HOMWOOD SUITES

3500 S. MERIDIAN

NO.	DATE	DESCRIPTION
07-15-21		CITY COMMENTS
11-05-21		CITY & FRUITLAND MUTUAL WATER COMMENTS

OVERALL SITE PLAN
C-1

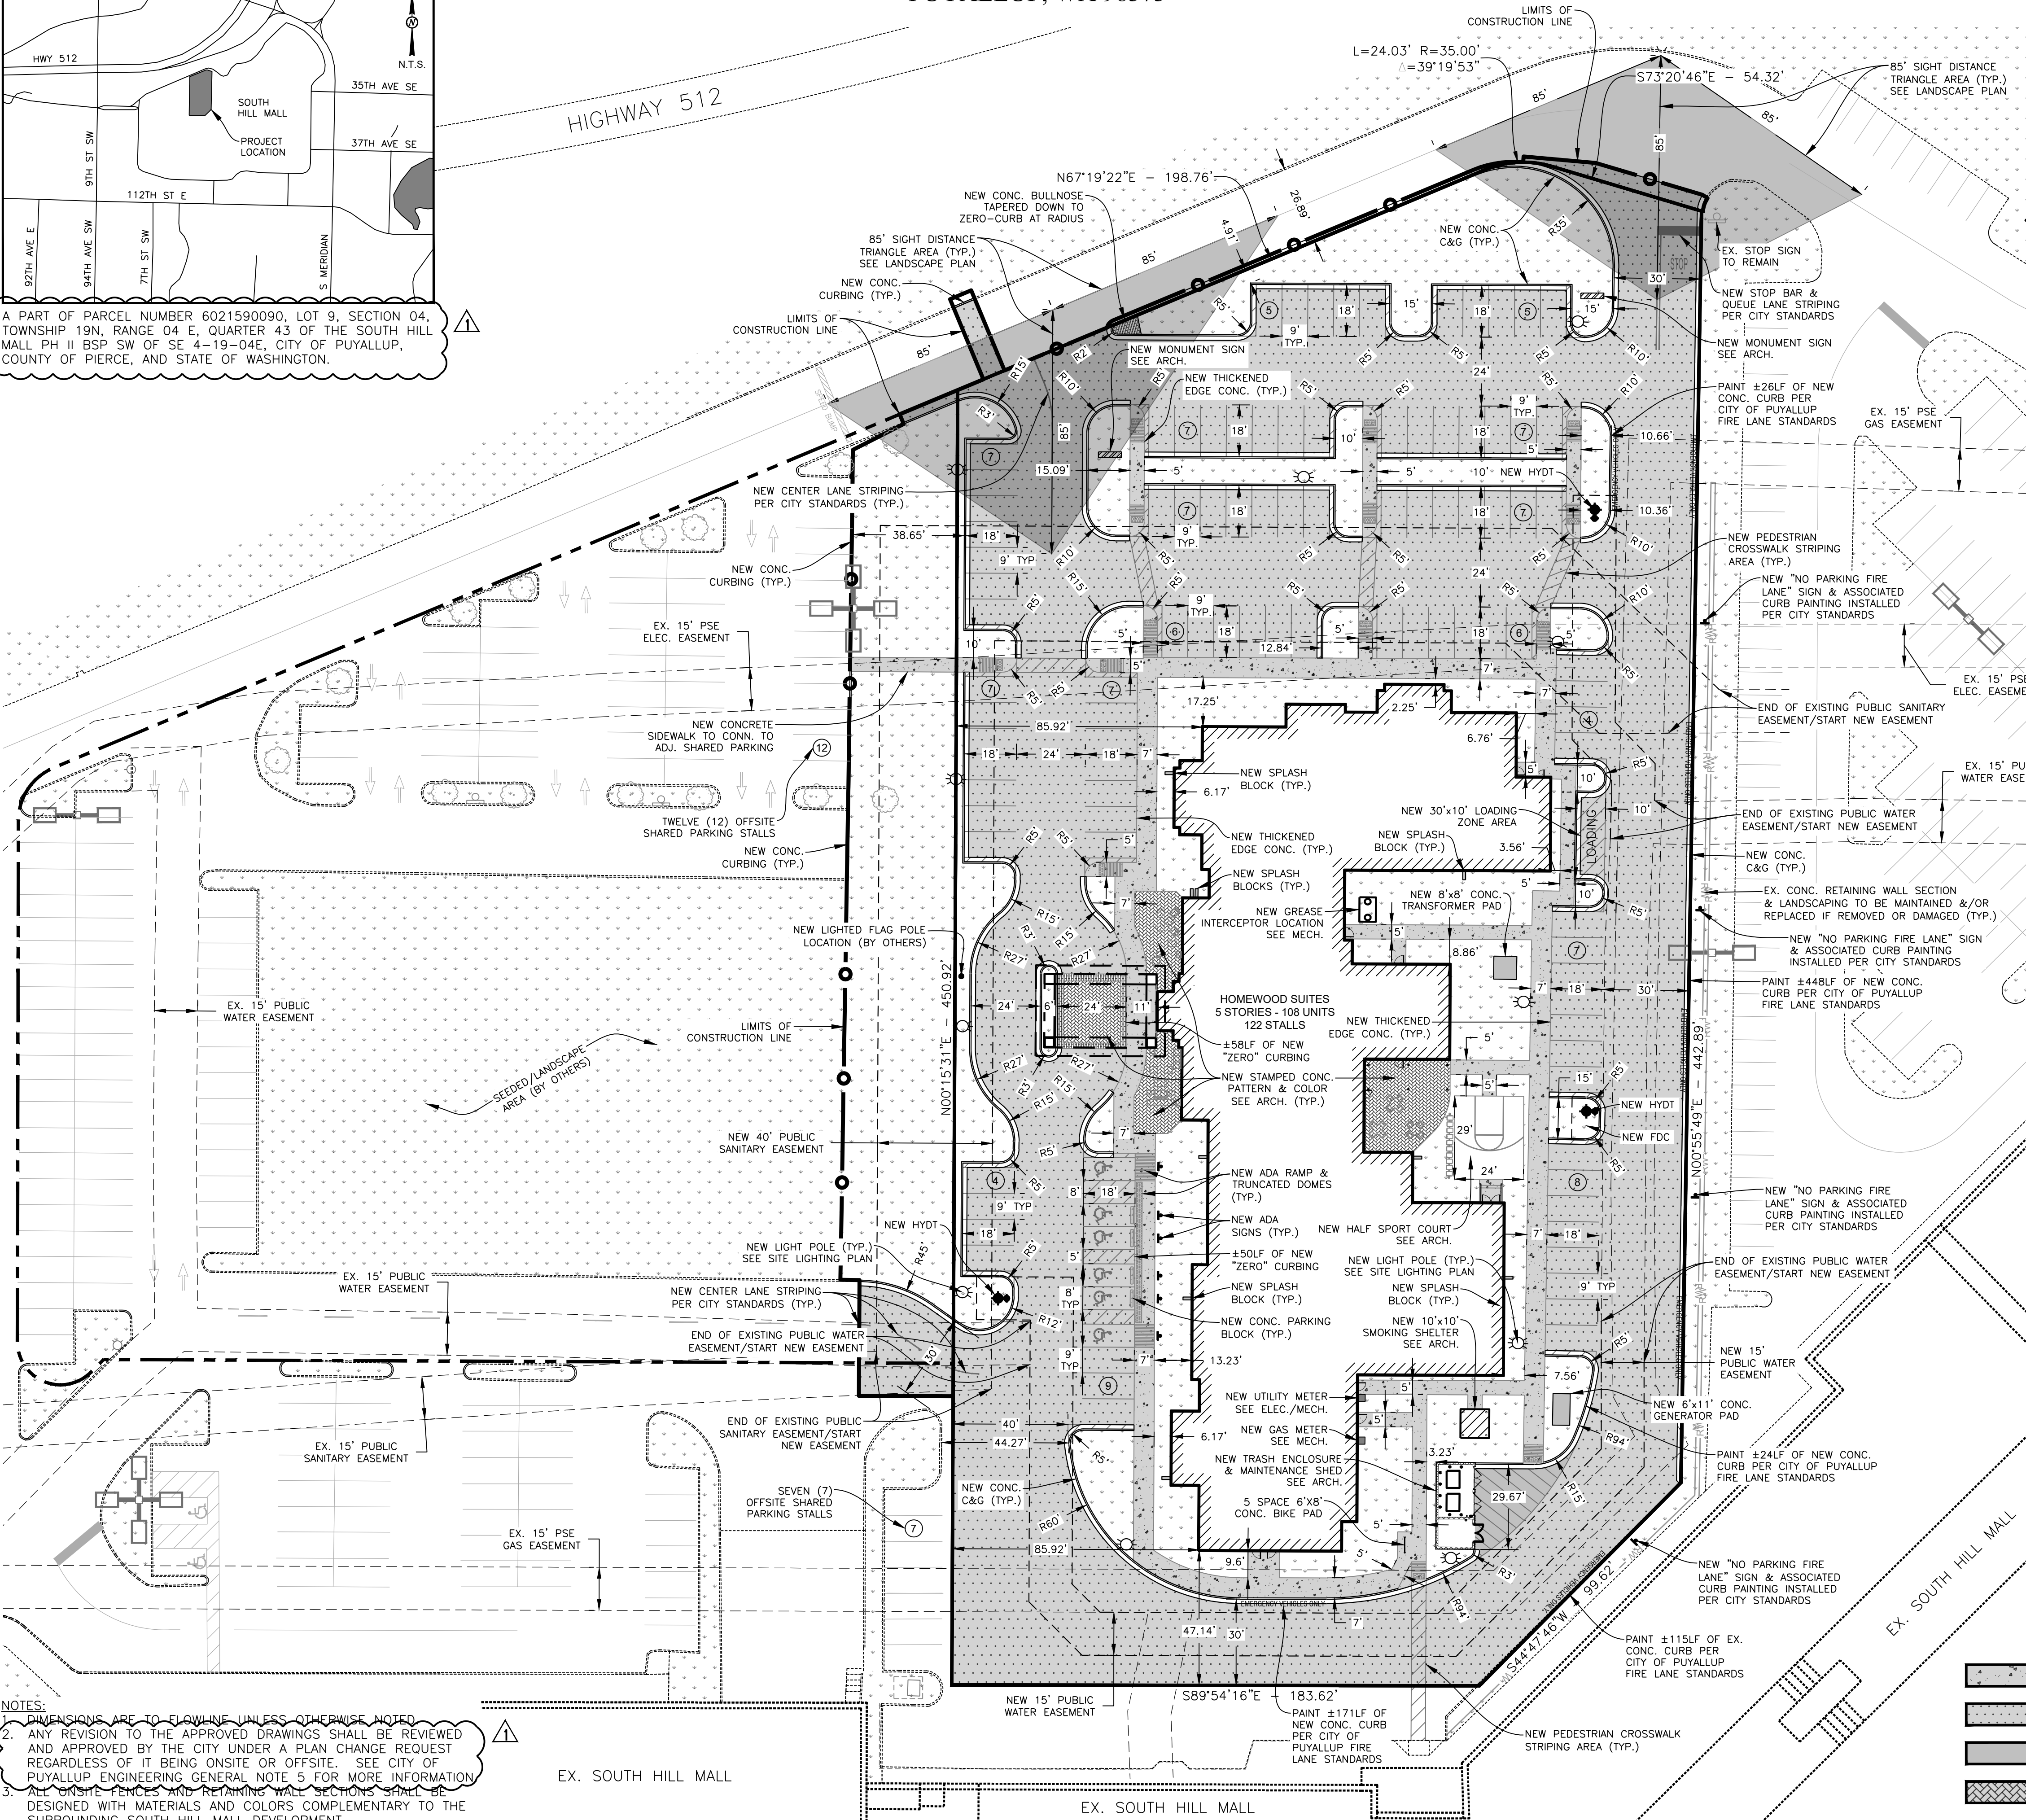
- CITY COMMENTS - 07-13-21**
- ADDED LEGAL DESCRIPTION BELOW THE VICINITY MAP
 - REVISED PLAN APPROVAL NOTE PER CoP ENGINEERING GENERAL NOTE 5
 - ADDED PLAN SHEETS FOR THE ADA RAMP IMPROVEMENTS PIECE
 - ADDED CoP APPROVAL STAMPS
- CITY & WATER COMMENTS - 11-05-21**
- REMOVED THE OFFSITE ADA IMPROVEMENTS PLAN SHEETS FROM THIS SET FOR SEPARATE APPLICATION/REVIEW
 - ADDED PLAN SHEETS FOR THE STORMWATER PRODUCT MANUFACTURER DETAILS

SURVEY OVERLAY
 &
 DEMOLITION PLAN

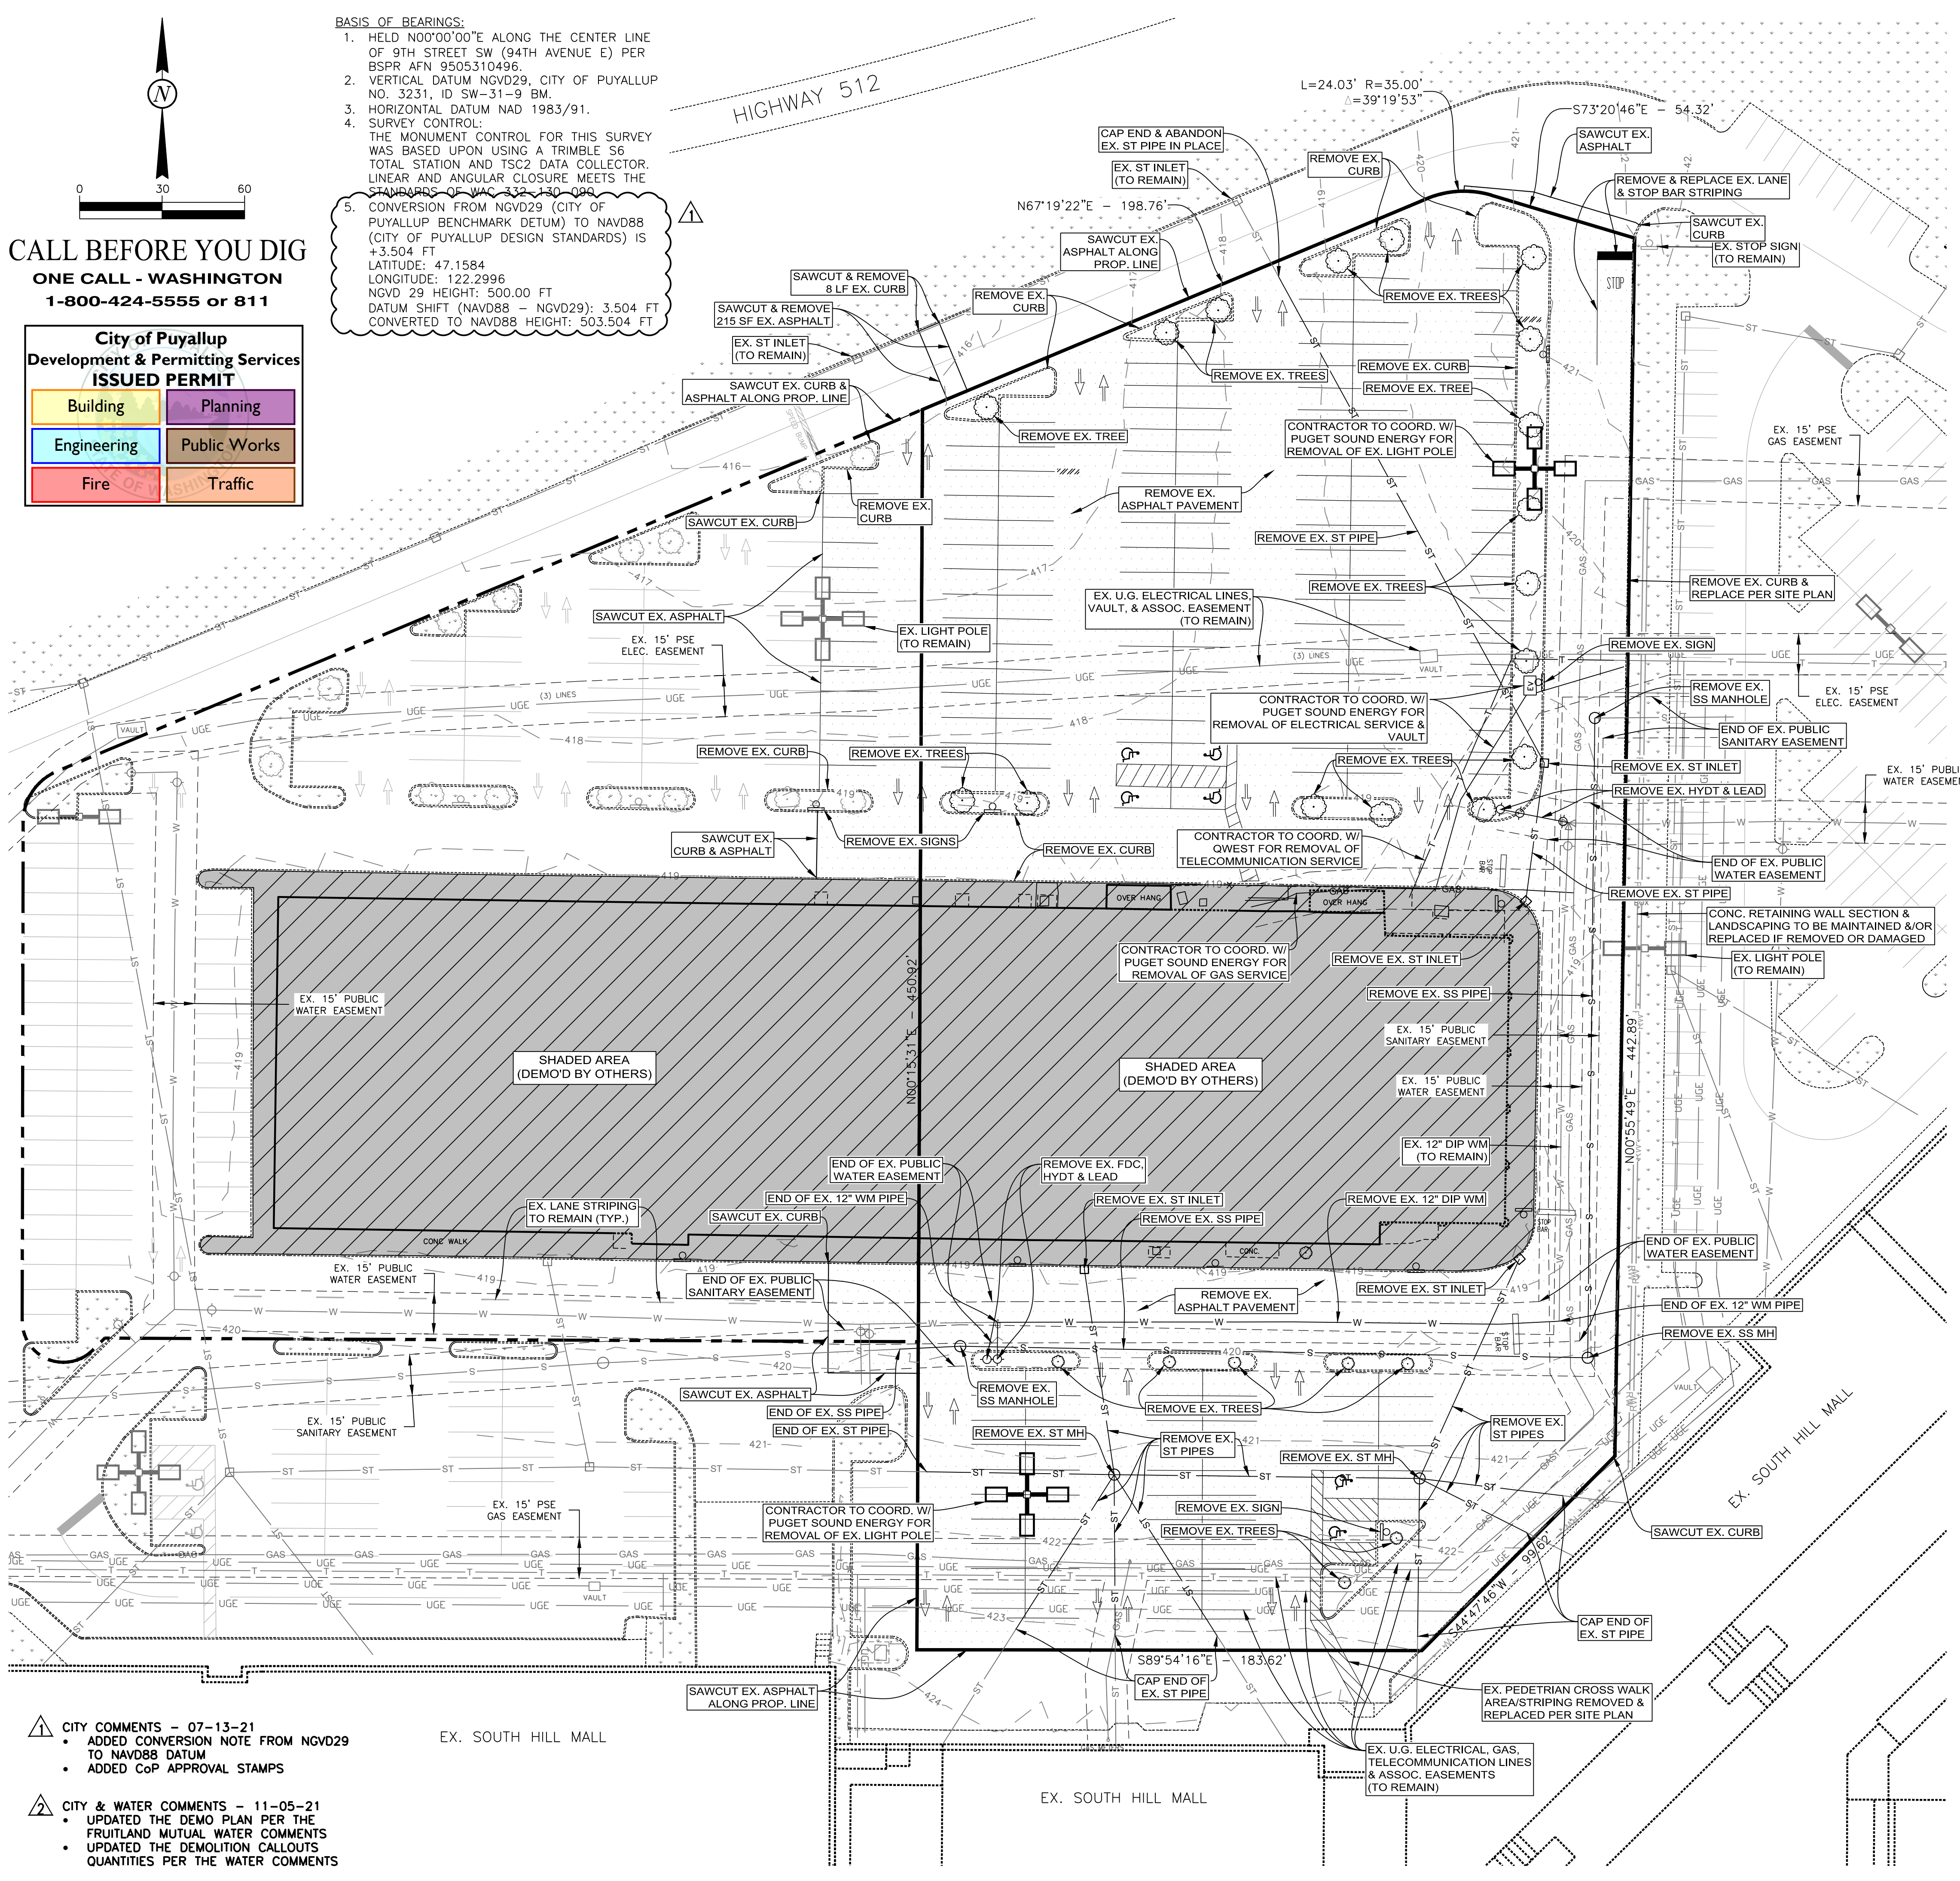
- CITY COMMENTS - 07-13-21**
- ADDED CONVERSION NOTE FROM NGVD29 TO NAVD88 DATUM
 - ADDED CoP APPROVAL STAMPS
- CITY & WATER COMMENTS - 11-05-21**
- UPDATED THE DEMO PLAN PER THE FRUITLAND MUTUAL WATER COMMENTS
 - UPDATED THE DEMOLITION CALLOUTS QUANTITIES PER THE WATER COMMENTS

SANITARY & WATER UTILITY PLAN
C-4

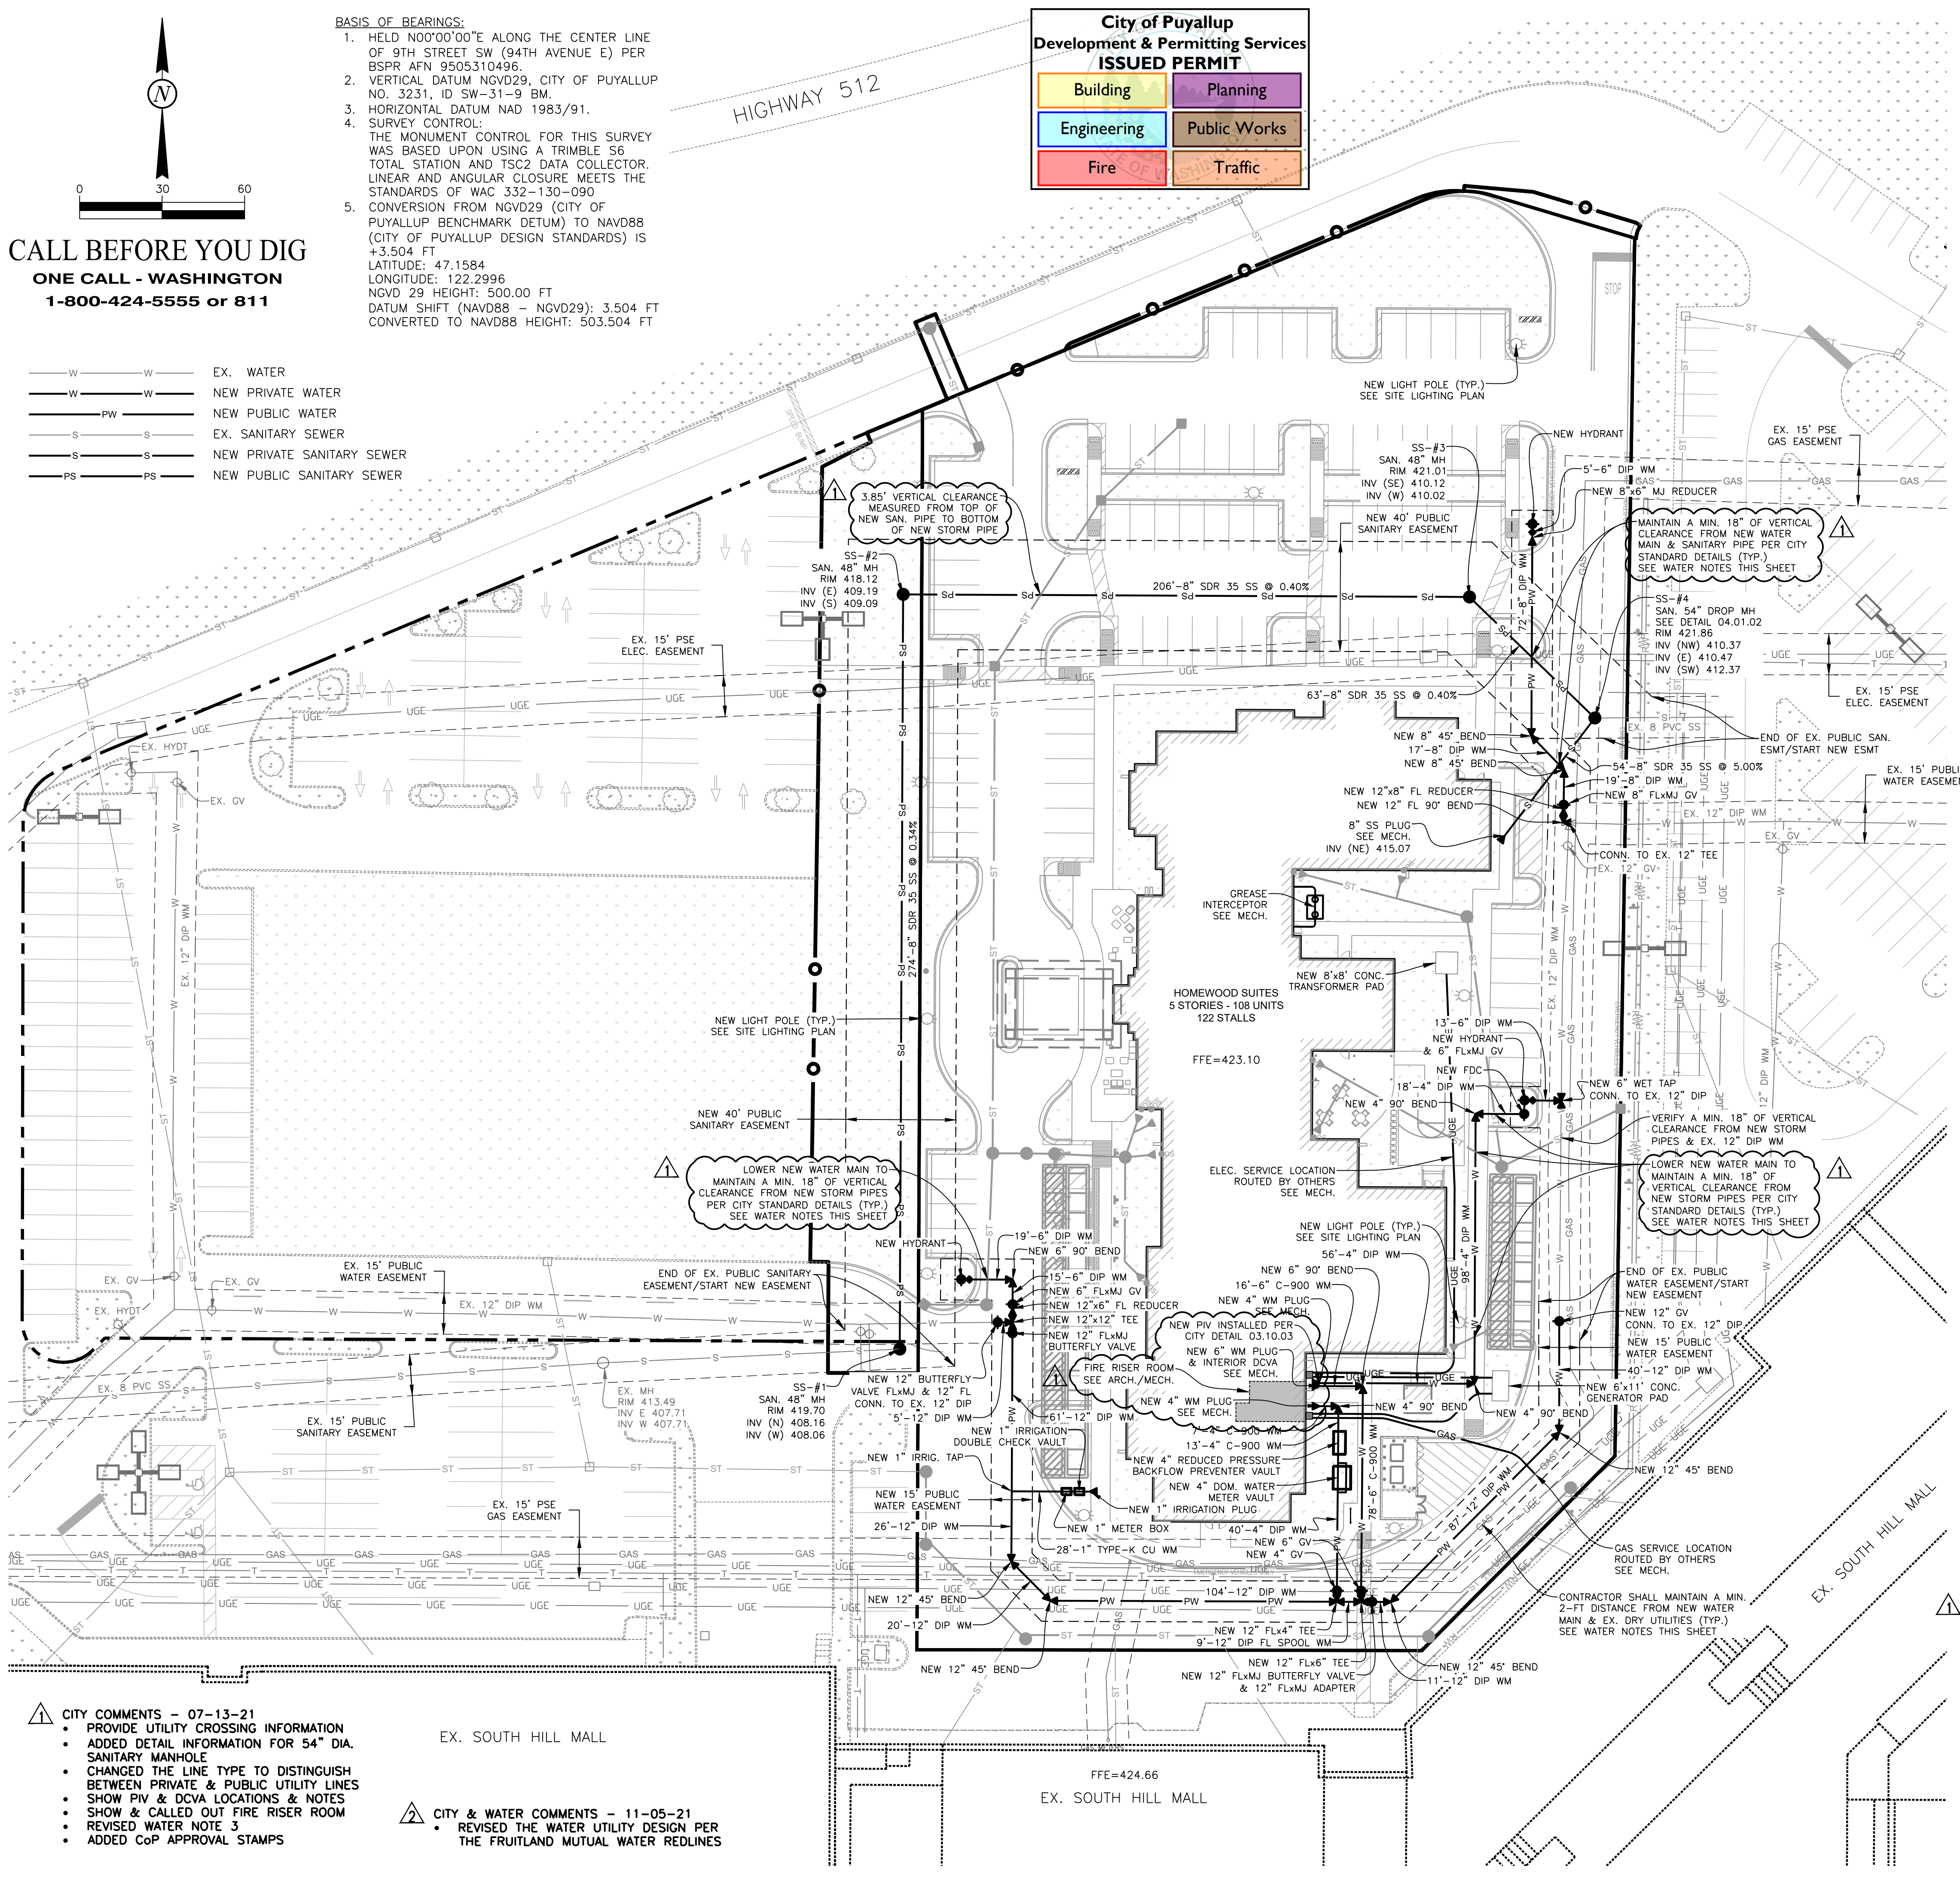
CITY COMMENTS - 07-13-21
 • PROVIDE UTILITY CROSSING INFORMATION
 • ADDED DETAIL INFORMATION FOR 54" DIA. SANITARY MANHOLE
 • CHANGED THE LINE TYPE TO DISTINGUISH BETWEEN PRIVATE & PUBLIC UTILITY LINES
 • SHOW PIV & DCVA LOCATIONS & NOTES
 • SHOW & CALLED OUT FIRE RISER ROOM
 • REVISED WATER NOTE 3
 • ADDED COP APPROVAL STAMPS

CITY & WATER COMMENTS - 11-05-21
 • REVISED THE WATER UTILITY DESIGN PER THE FRUITLAND MUTUAL WATER REDLINES
